E4360A-02

## Information Only Service Note

## E4360A - Modular Solar Array Simulator

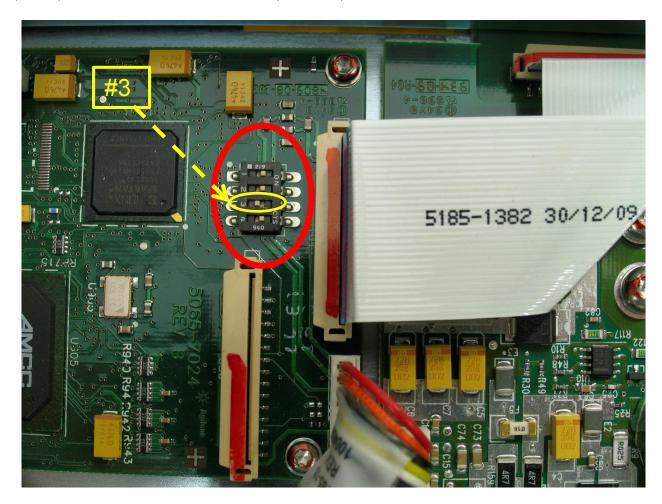
The Situation - Blue/white Front Panel LCD Display (below) has been obsoleted.

LCD (blue/white display assembly, p/n 2090-1031) has been discontinued by vendor. Replacement assembly (pictured later) is p/n 5067-6532 (amber in color). Difference in color is unfortunate, but cannot be altered.

1) New LCD display (5067-6532) is a mechanical & functional "drop-in" replacement for the original.

2) 4-pole dip switch on PPMC PCA must have pole #3 repositioned to "off" as shown below:

3) Instrument firmware must be version D.04.01 or newer for proper operation of this display.
